**PLAN REVIEW CONDITIONS**

Permit No: PRCOM20200445  
Project Title: MID-CONTINENT PUBLIC LIBRARY - COLBERN ROAD  
Project Address: 1000 NE COLBERN RD, LEES SUMMIT, MO 64064  
Parcel Number: 52500011300000000  
Location / Legal: RICE ACRES LOT 1  
Description:  
Type of Work: NEW COMMERCIAL  
Occupancy Group: ASSEMBLY FOR OUTDOOR ACTIVITIES INCL. STADIUMS, GRANDSTAND, AMUSEMENT PARKS  
Description: NEW LIBRARY

## **Plan Review Conditions Response**

## Supplemental Instructions #03

**01** ENLARGED PLAN - CAFE + RESTROOMS  
1/4" = 1'-0"

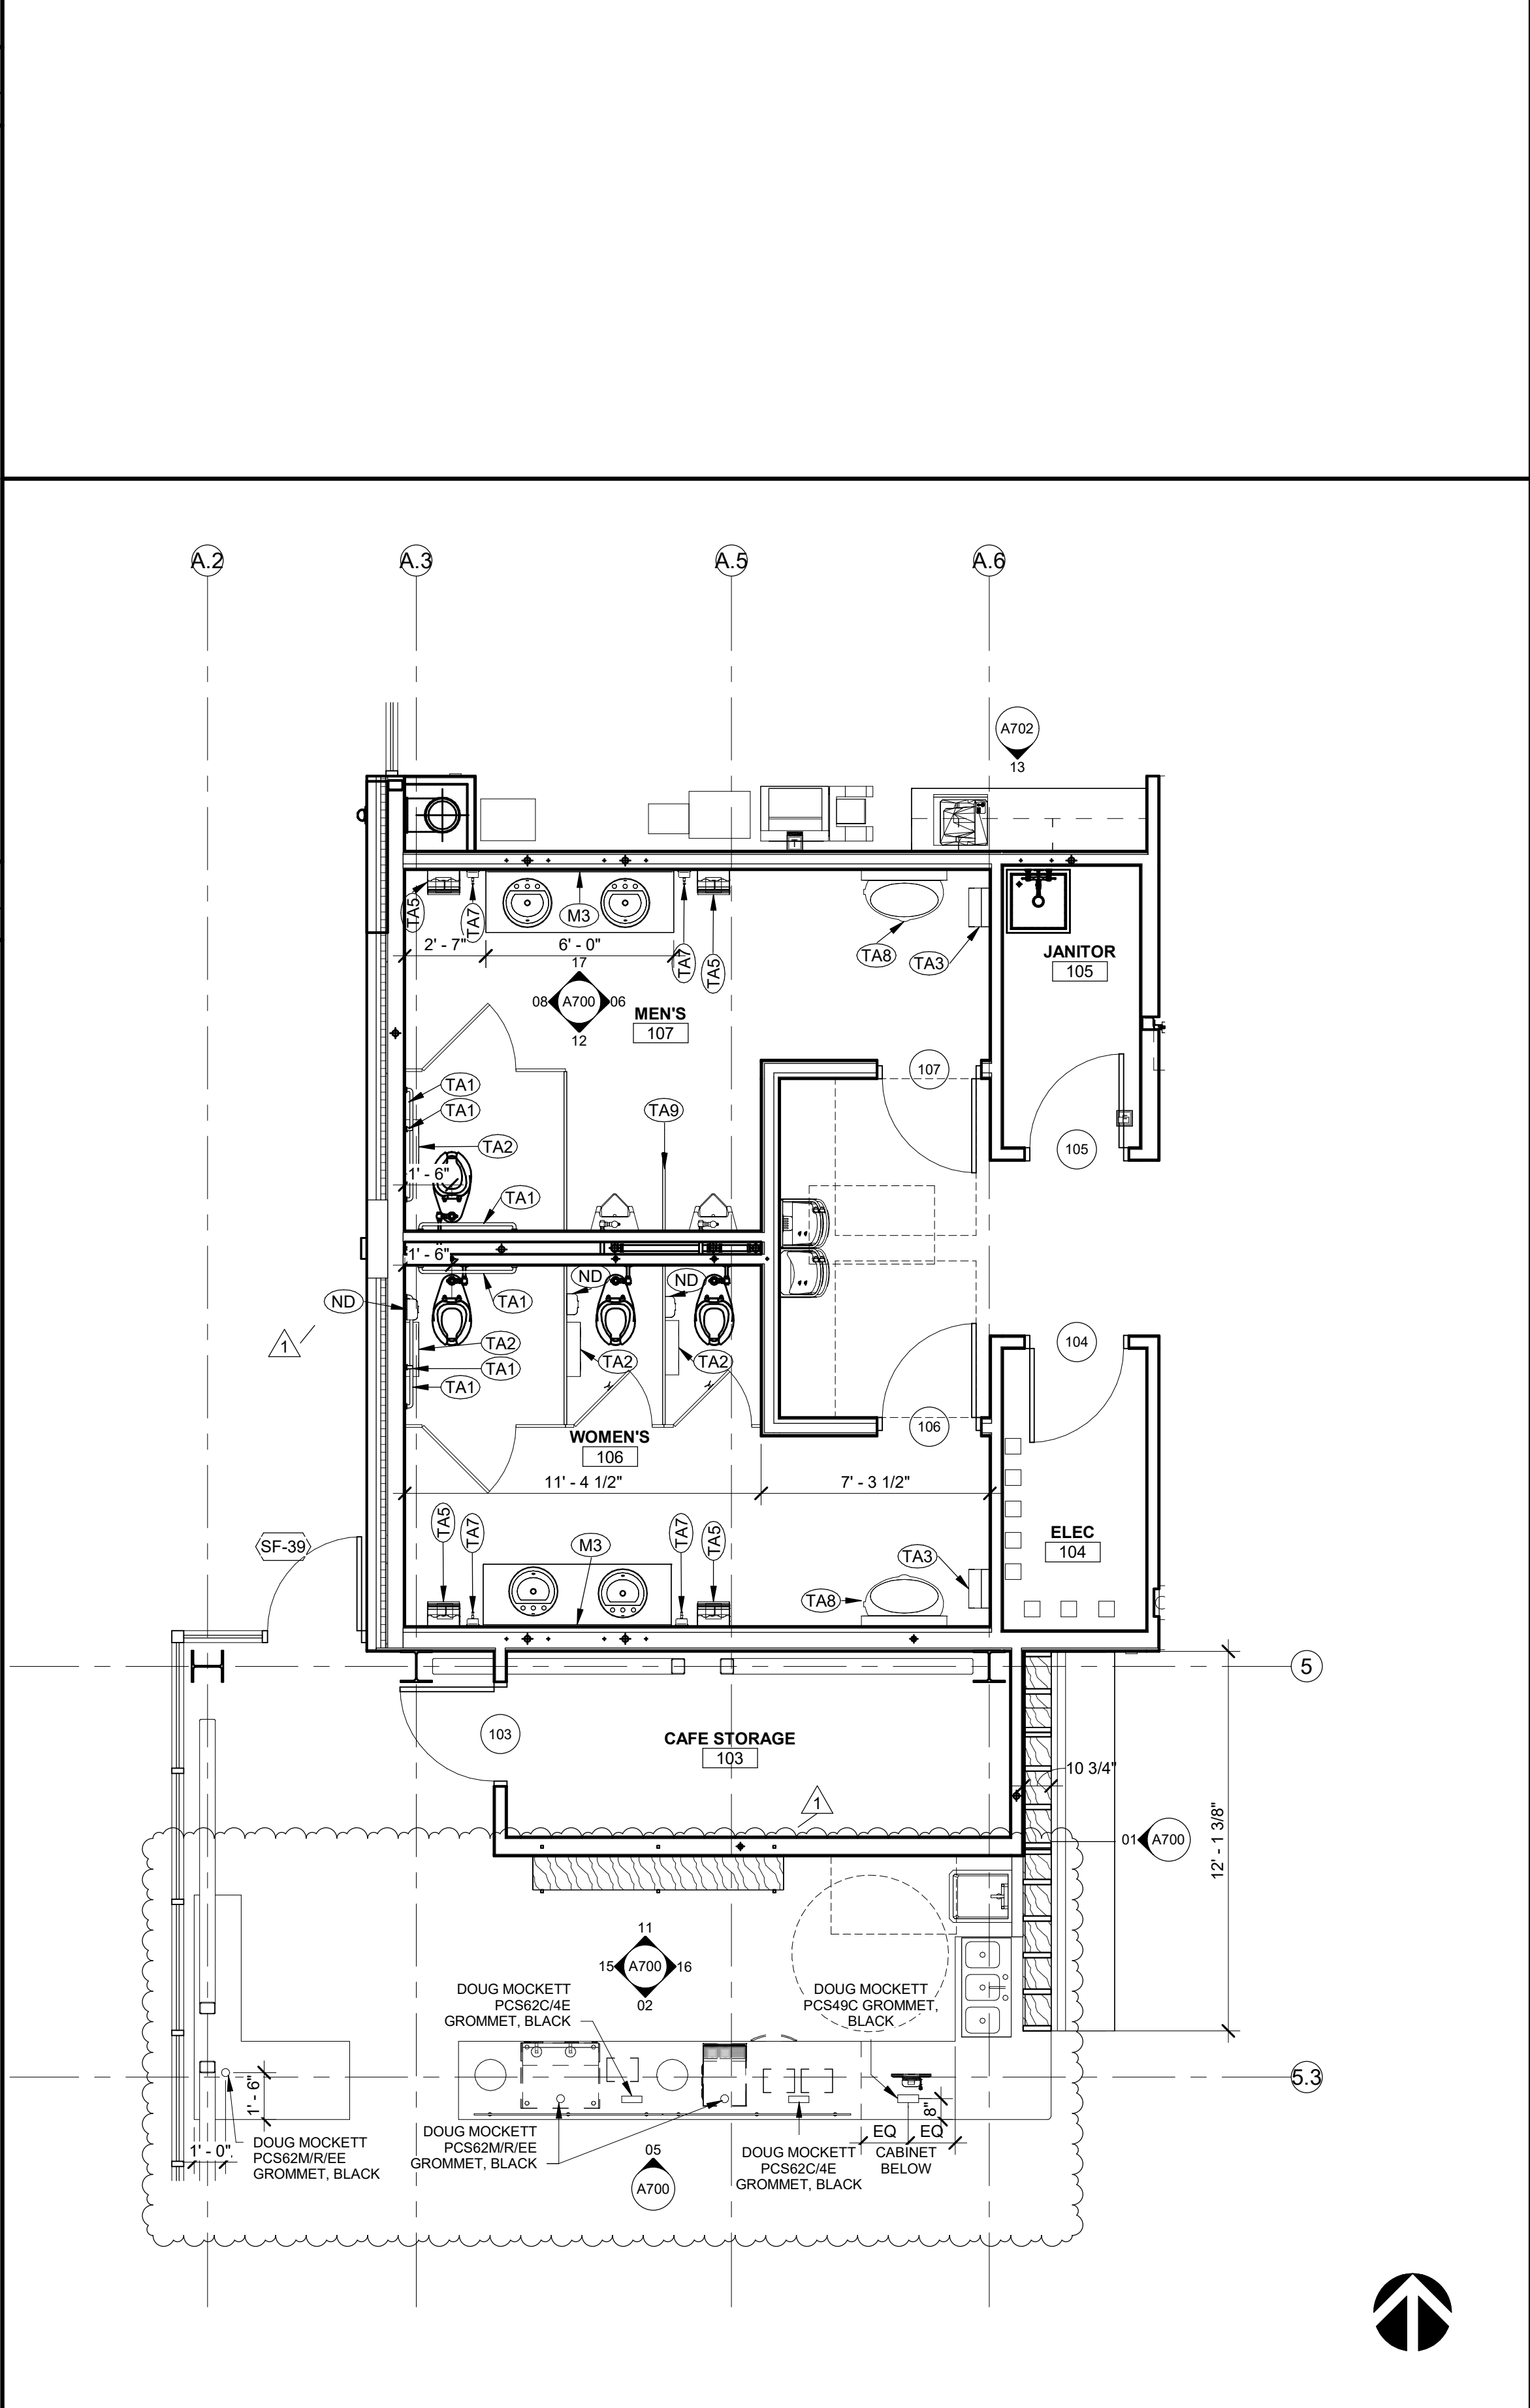
5. For the Health Department review contact Deb Sees with the Jackson County Public Works Department, Environmental Services Division, at (816) 847-7070. Health Department approval is required prior to receiving any type of building permit from the City of Lee's Summit.

4. Contractor (JE Dunn) will obtain a demolition permit for that scope of work.
5. The Health department has approved the plan with the addition of a small three compartment sink as shown on the attached MEP sheets P100, P200, and P300 and architectural sheets A100, A101, and A150.

Drawing No. **A400**

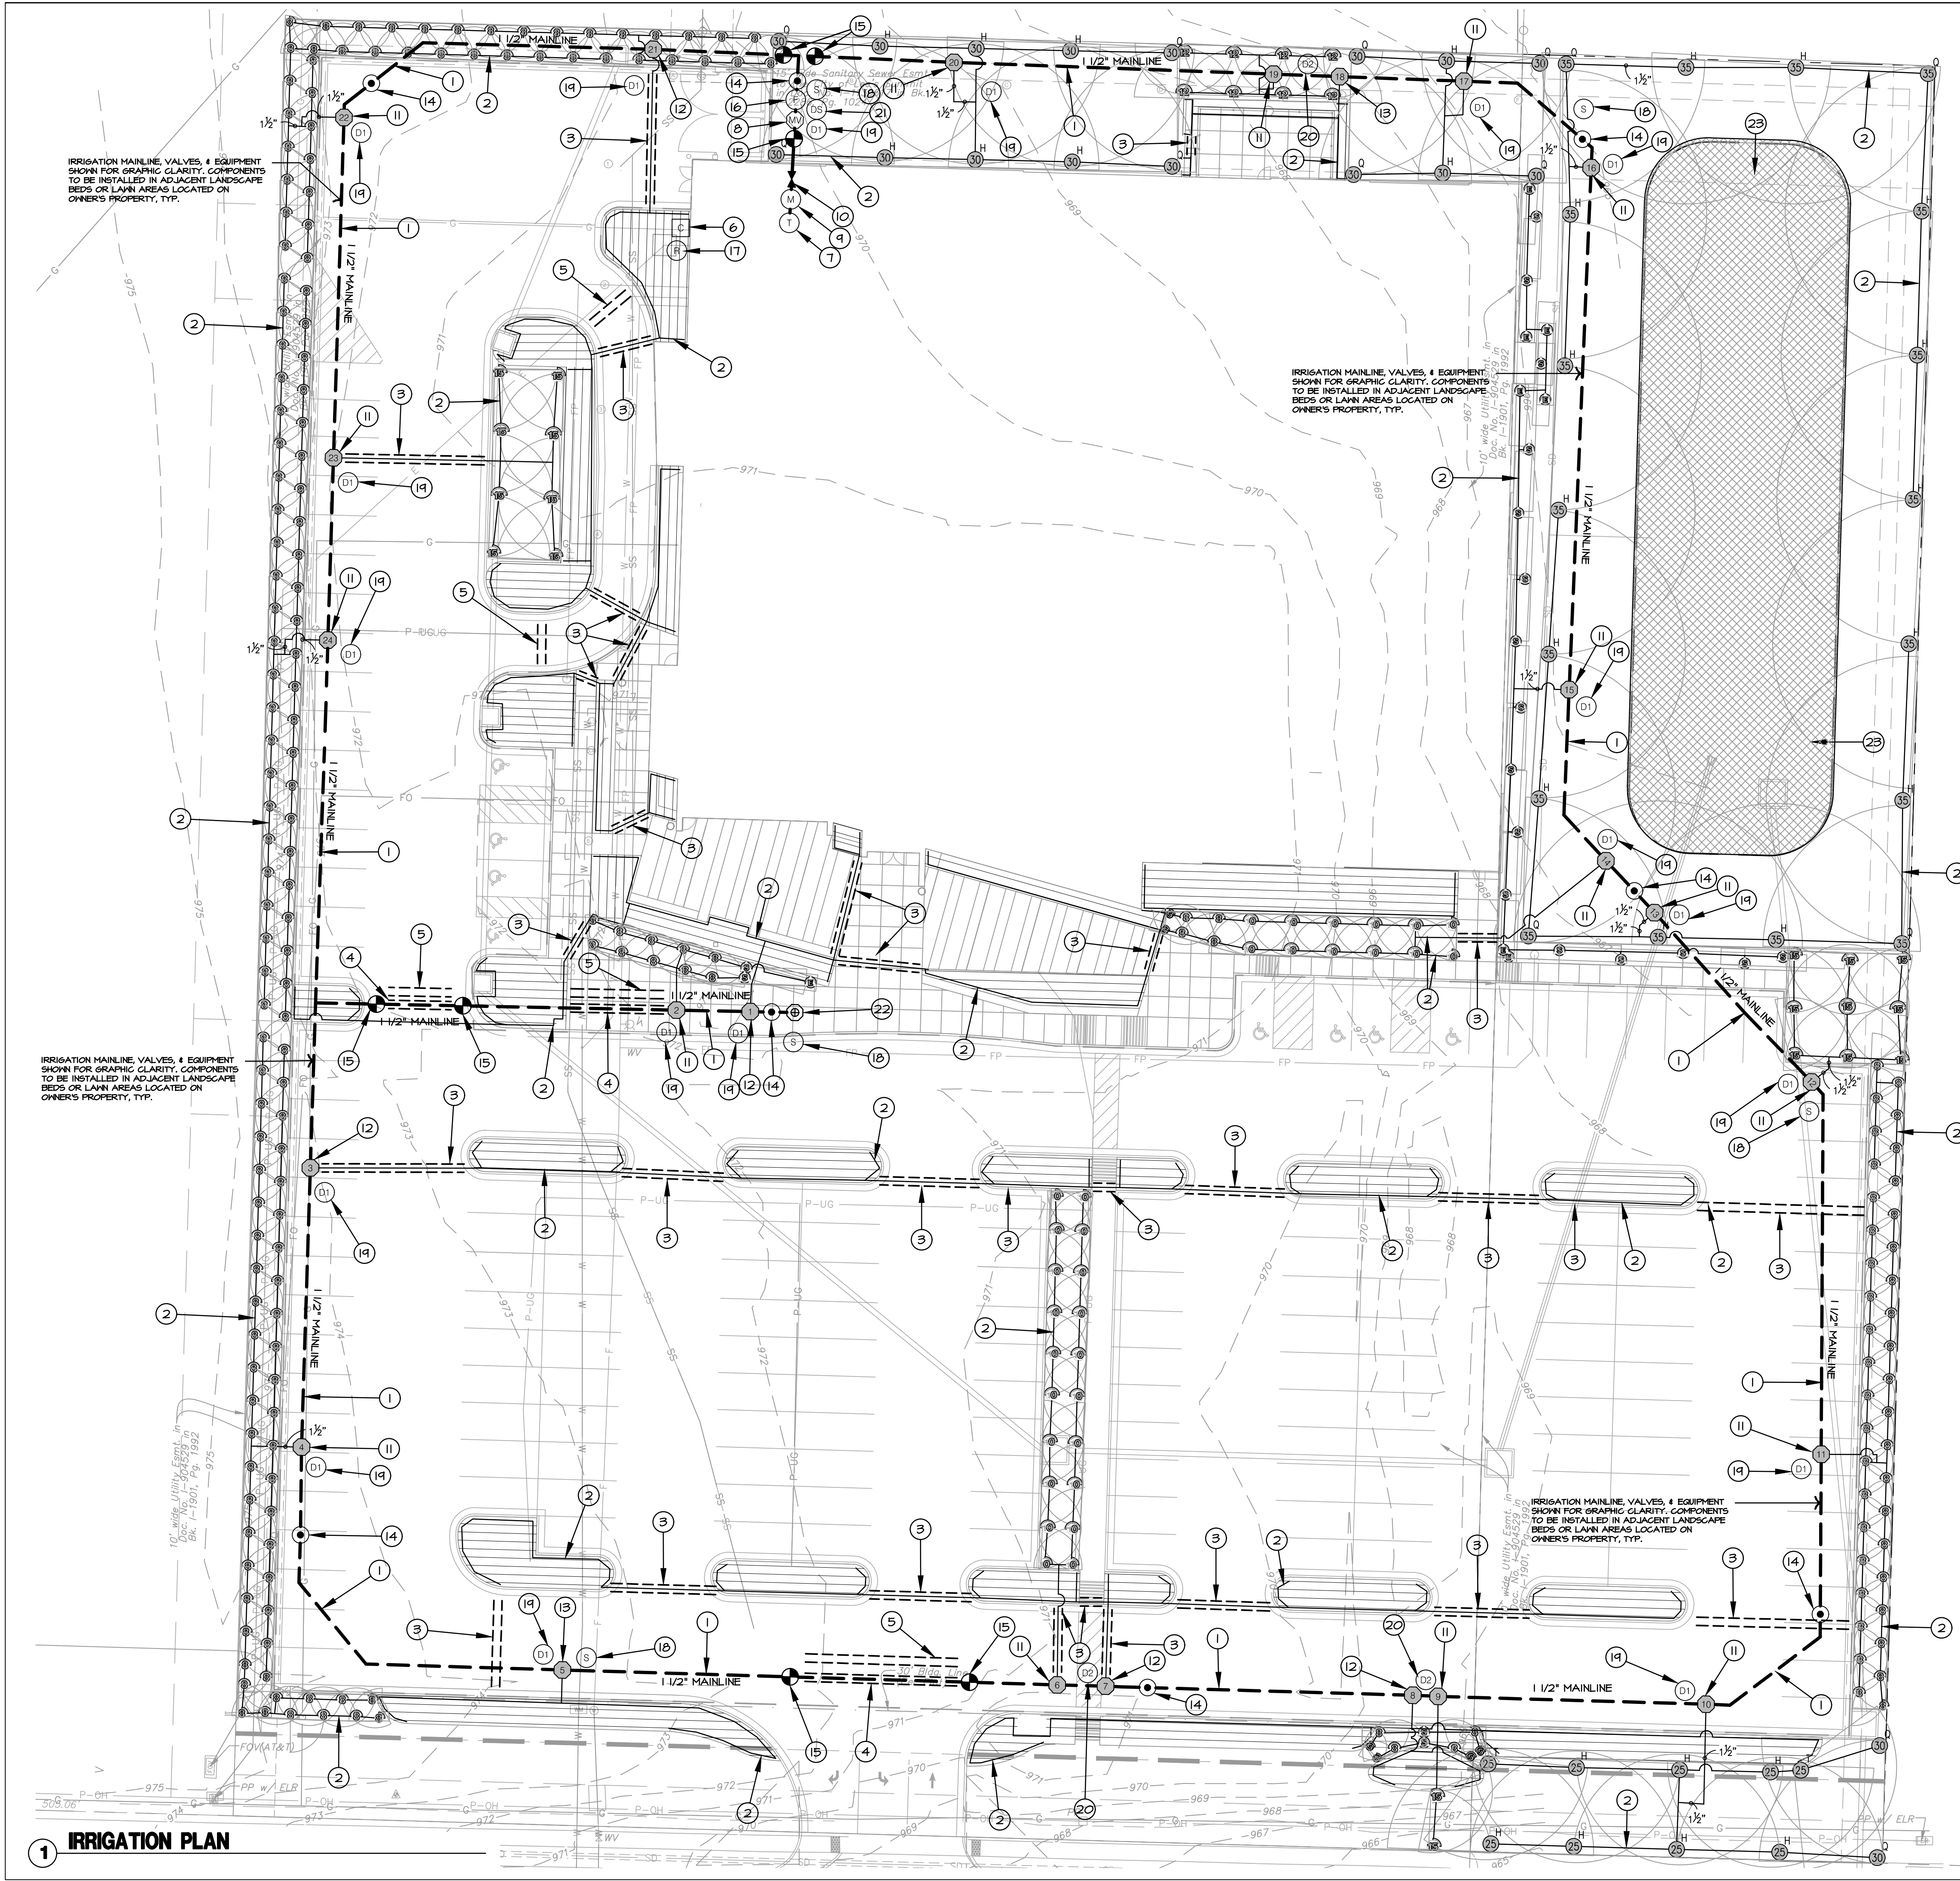
- Clarify use and occupant load of Staff Area 137. Sliding doors are only allowed with occupant load of 10 or less. Furniture conflicts with 1/150 loading. If sliding doors are actually to be used as "movable partitions" they would have to be labelled as such.

- Clarify use of center hinged pivoting doors. If they are only to be used as "movable partitions" they would have to be labelled as such.

Action required: Doors serving Receiving Room #117 are to swing in direction of egress and be equipped with panic hardware.

6. Health Department inspections will be requested by the contractor (JE Dunn)
8. See attached updated sheet A400 clarifying scheduled item 137 as “Telescoping Sliding Glass Partition.” It is called out on the door schedule because it requires a locking cylinder that is to be provided by the door hardware provider. Locating it on this schedule will help ensure the cylinder is provided.

11. See attached updated sheet A400 showing revisions to doors and hardware corresponding with previously submitted plans.
12. Civil, Landscaping, and MEP plans have all been updated to show the irrigation tap, backflow preventer, and meter inside the building. Civil and Landscaping plans have been submitted with the FDP submittal. Attached are the updated L601, P101, and P200 reflecting this change.

Drawing No. **L601**

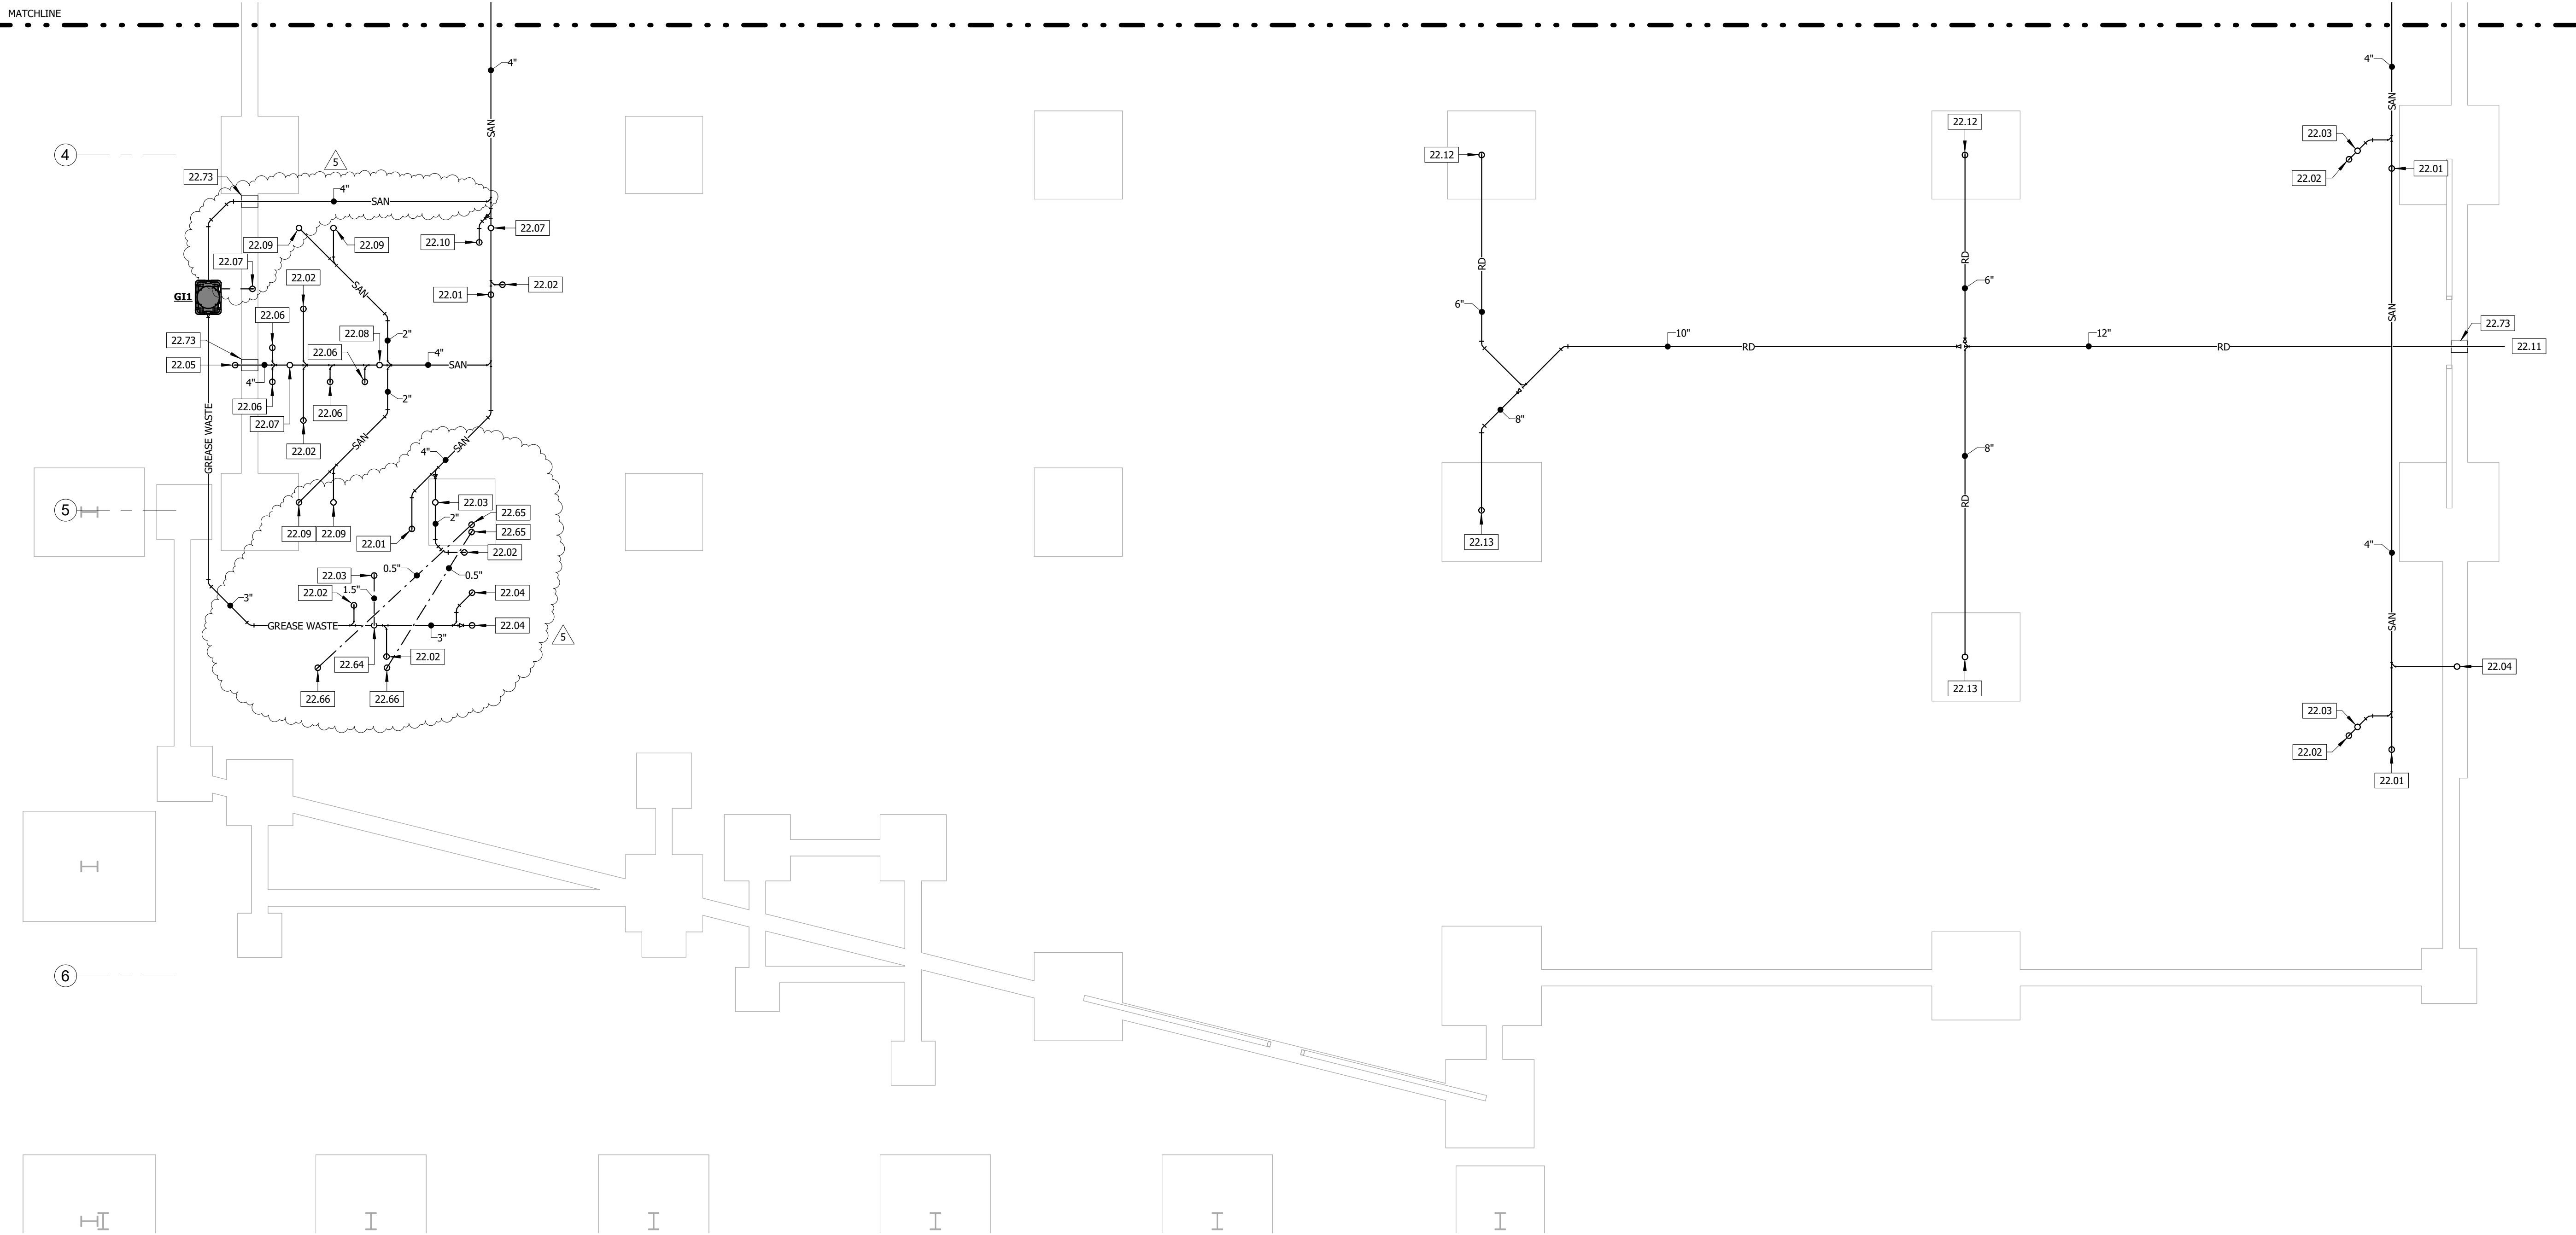
12. Irrigation system (as shown in FDP) is not reflected in MEP design.

**3/19/20 - P-series drawings must be coordinated with L600 series. i.e. Landscaping irrigation plans specify a connection to the domestic water system but the plumbing drawings do not.**
